**ADDENDUM 02**

Addendum #	02	Date Issued	04/01/2022
Project Name Job #	FB&T Arena and SJM Additions and Renovations – Bid Package 01	EAPC Project 20191170 OSE #R0319--23X/FBT	
Bid Date Time	04/07/2022	2:30pm

***SDSU First Bank & Trust Arena
Addition & Renovation
(Bid Package #1)***

DRAWING TITLE
FRAMING DETAILS

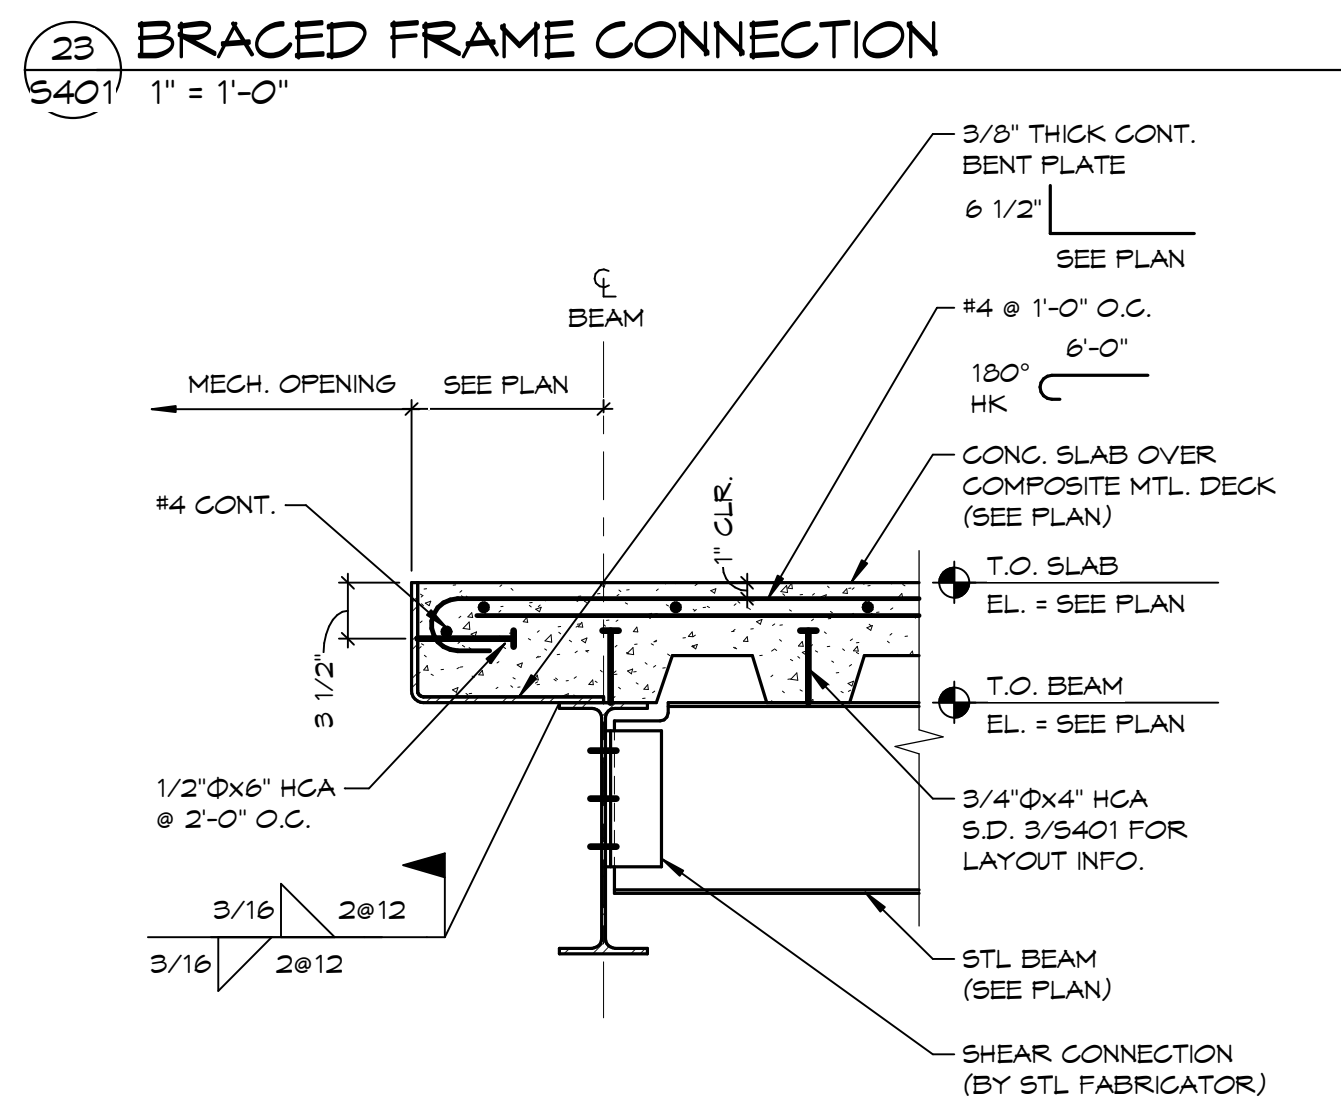
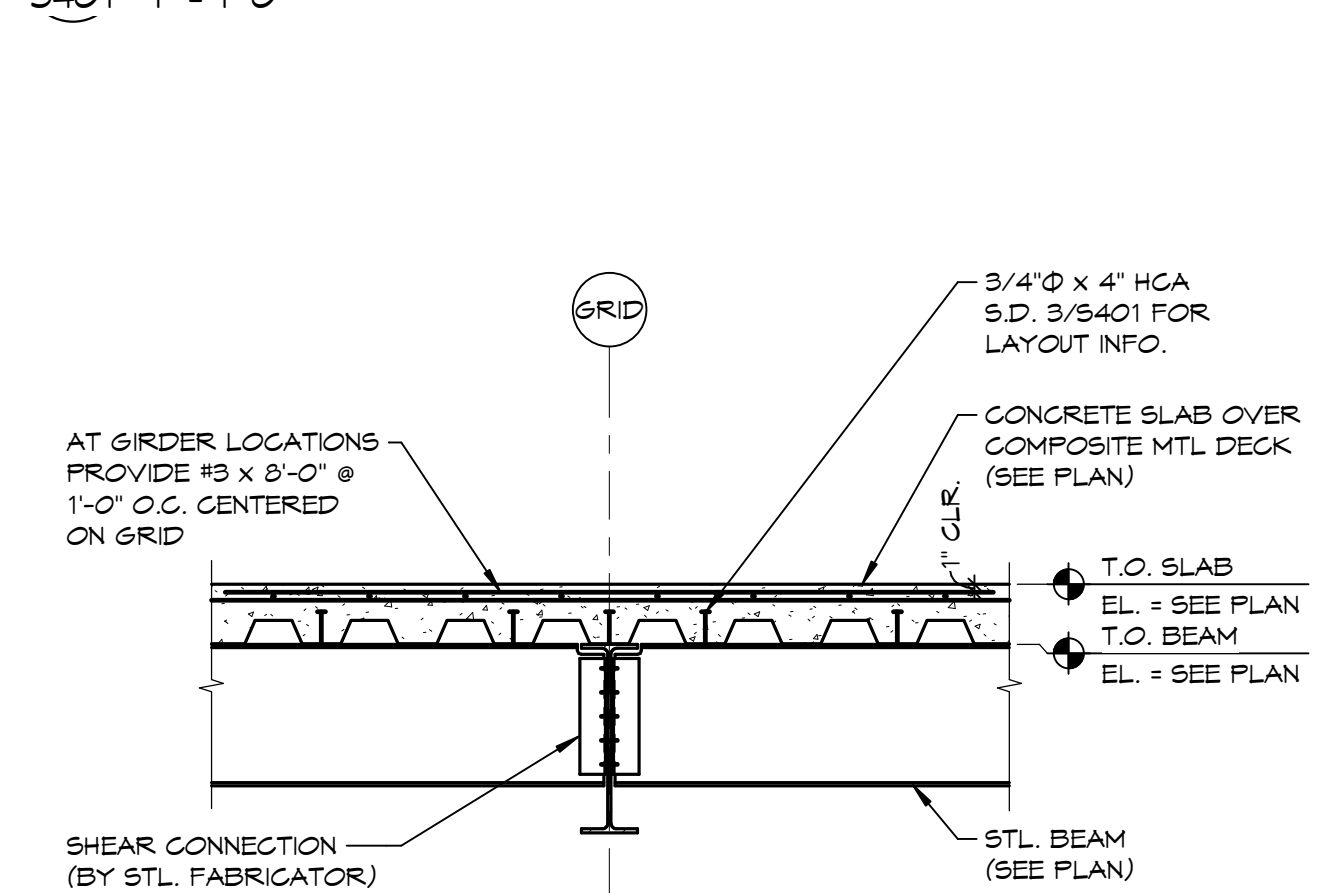
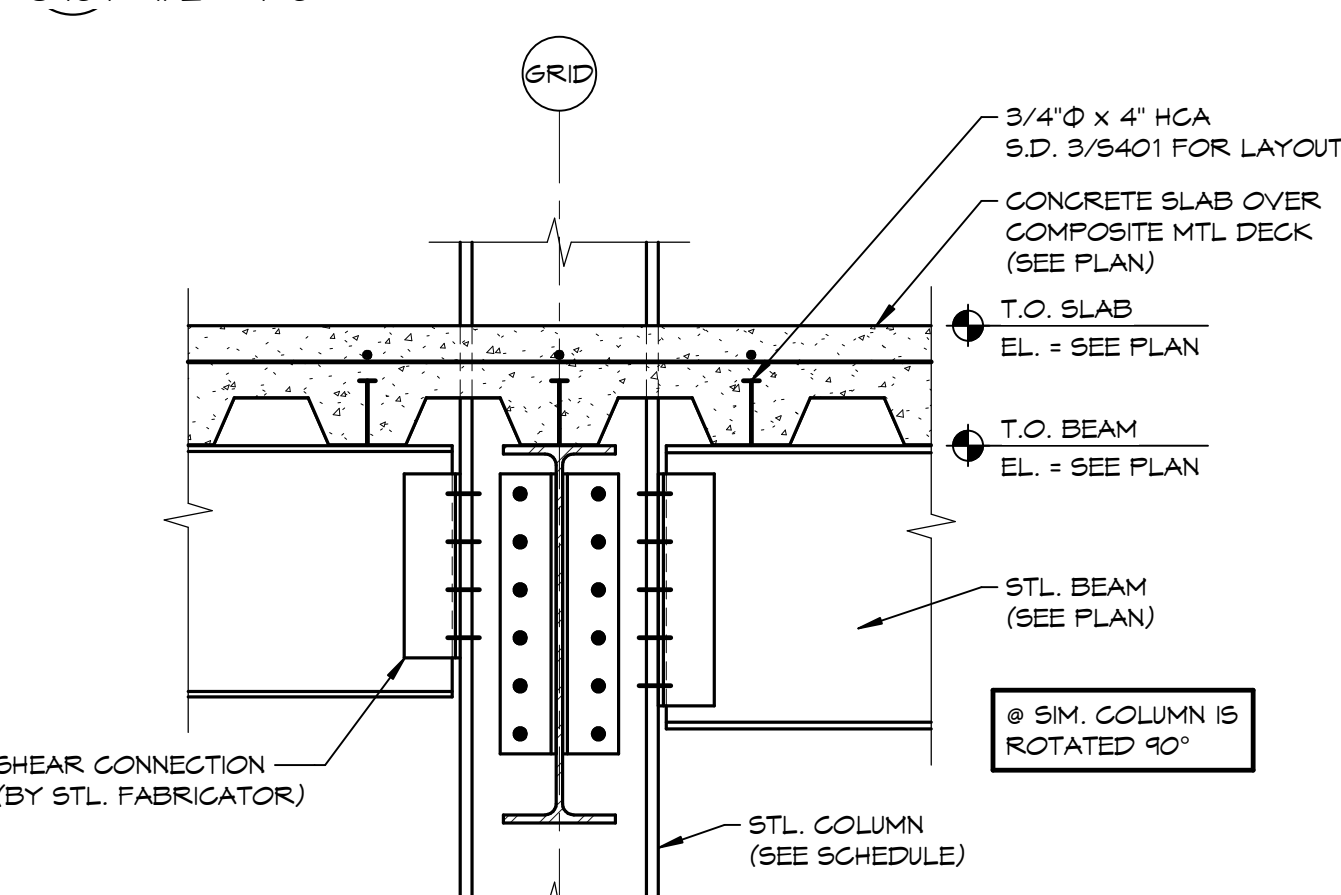
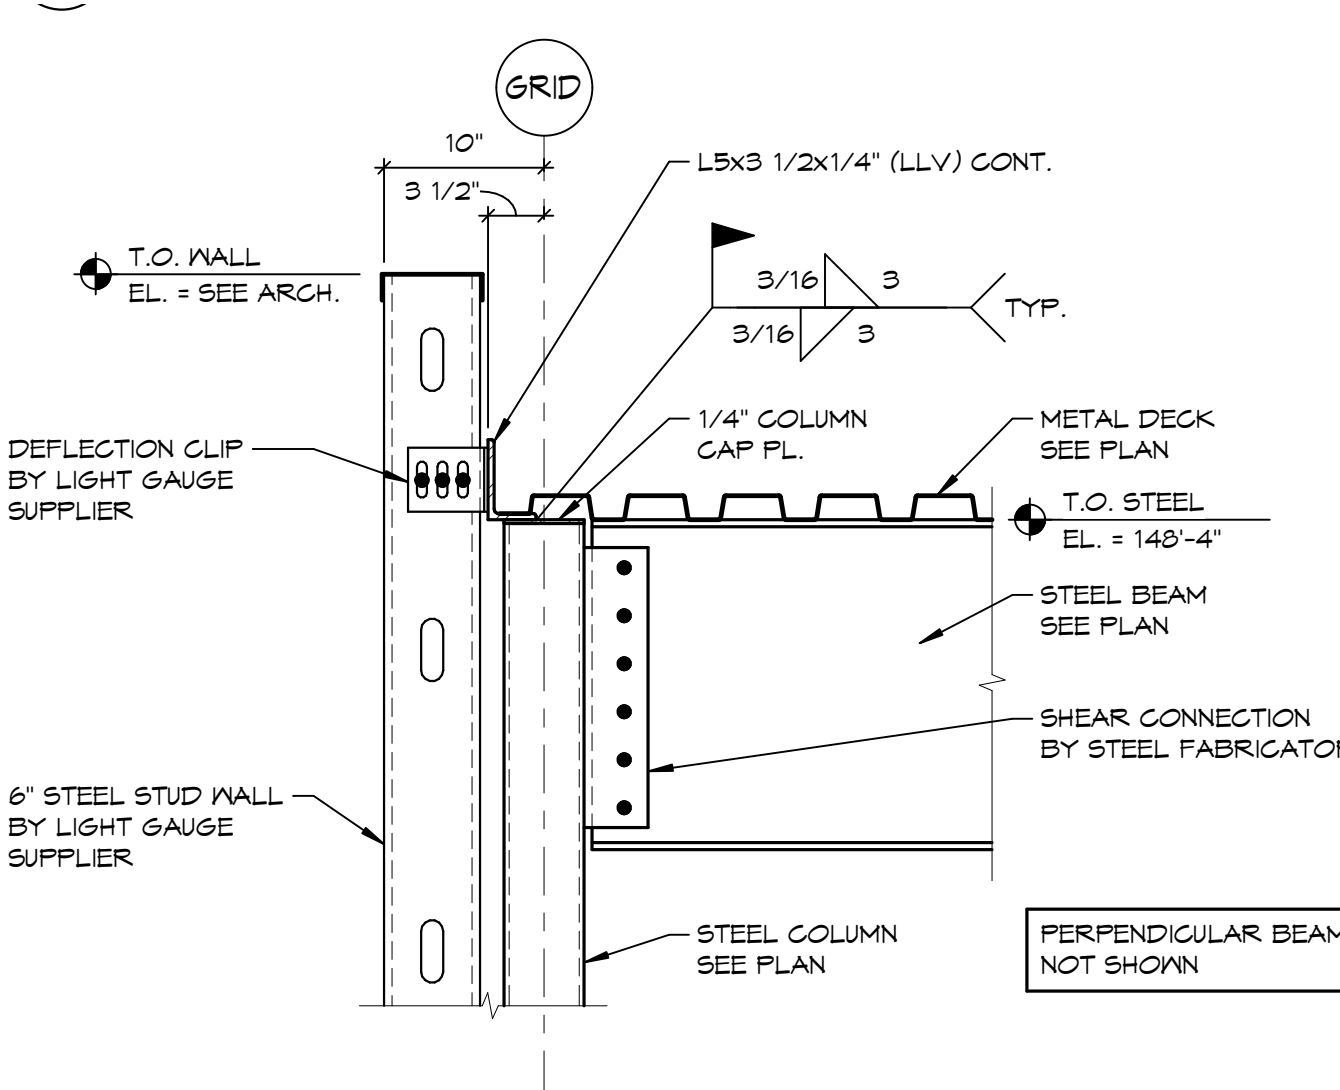
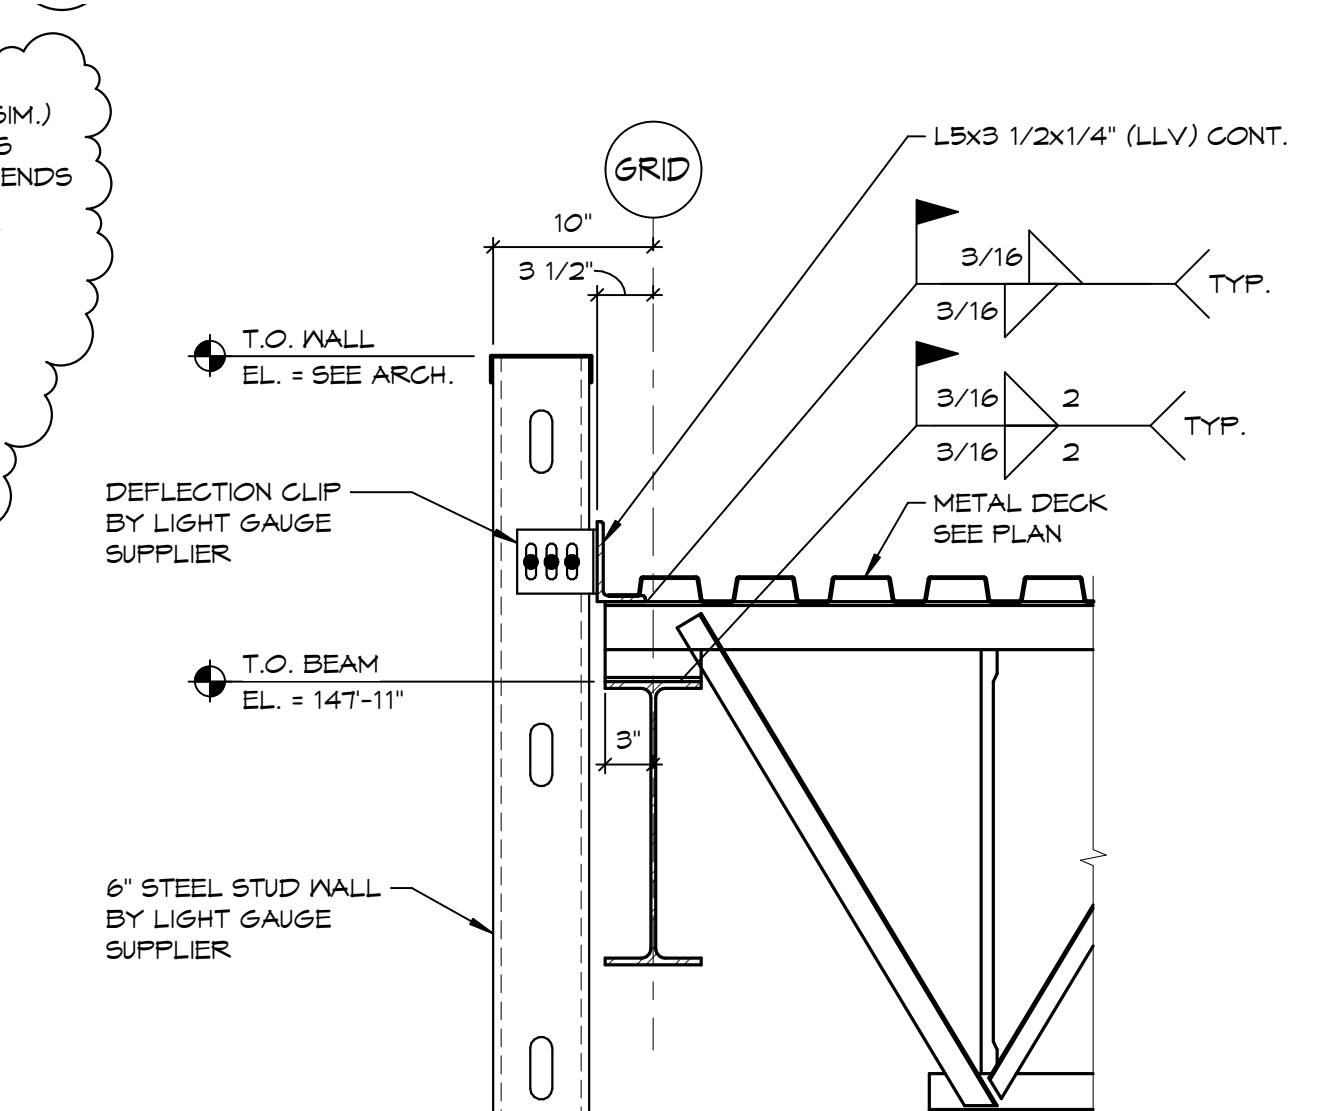
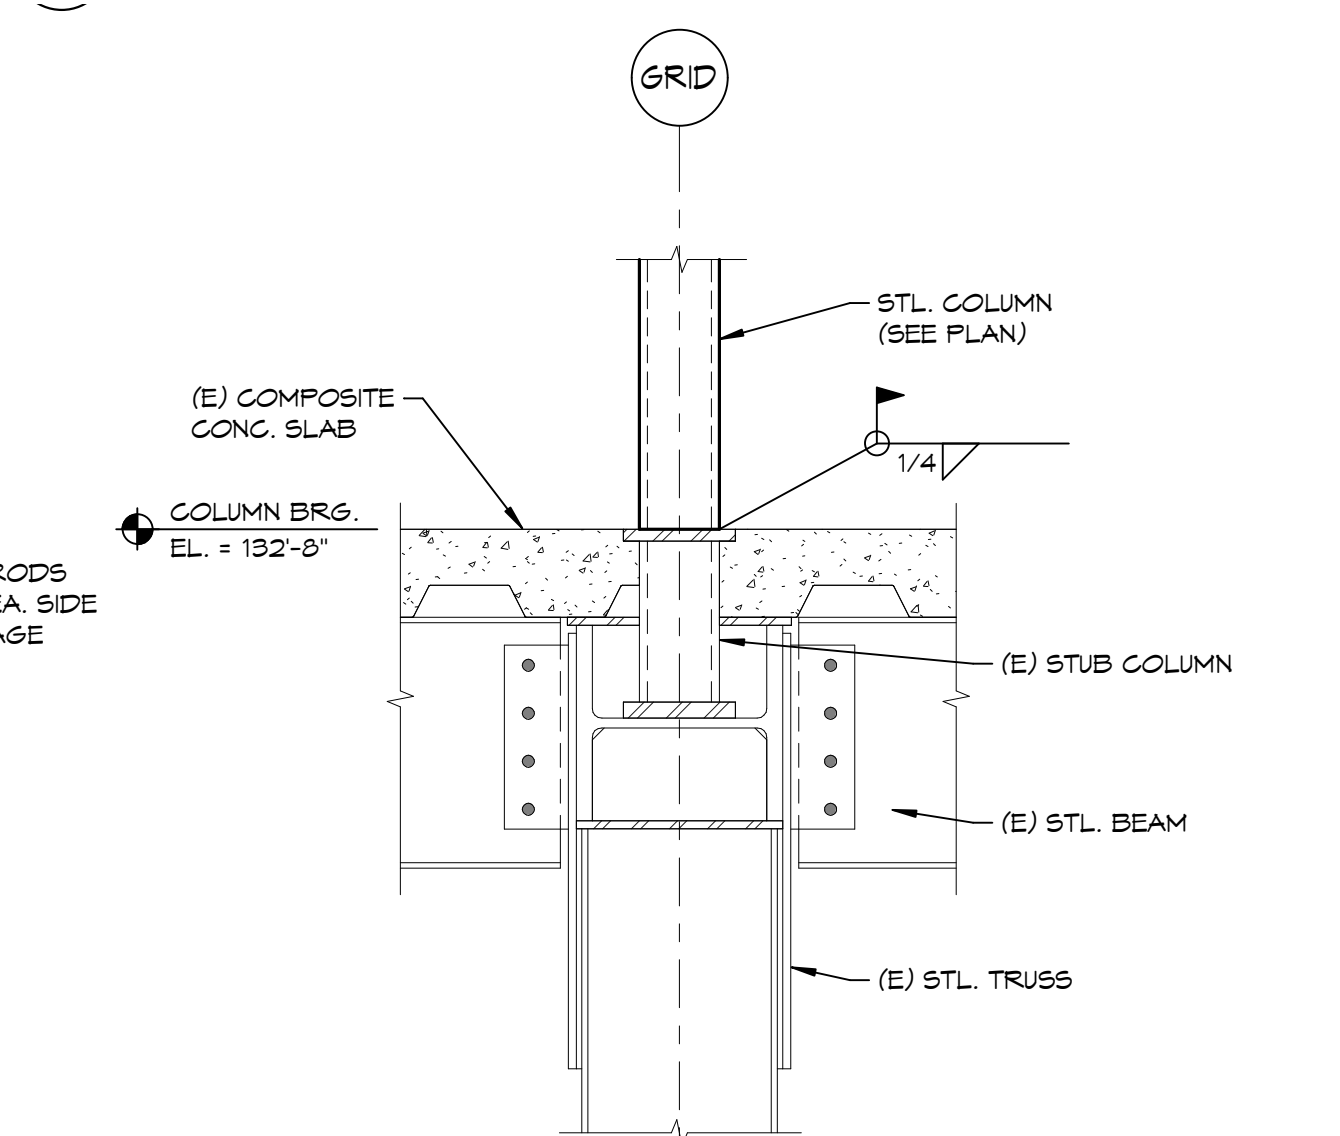
S302	Revise/add details per attached S302
S401	Revise details per attached S401
S407	Revise details per attached S407
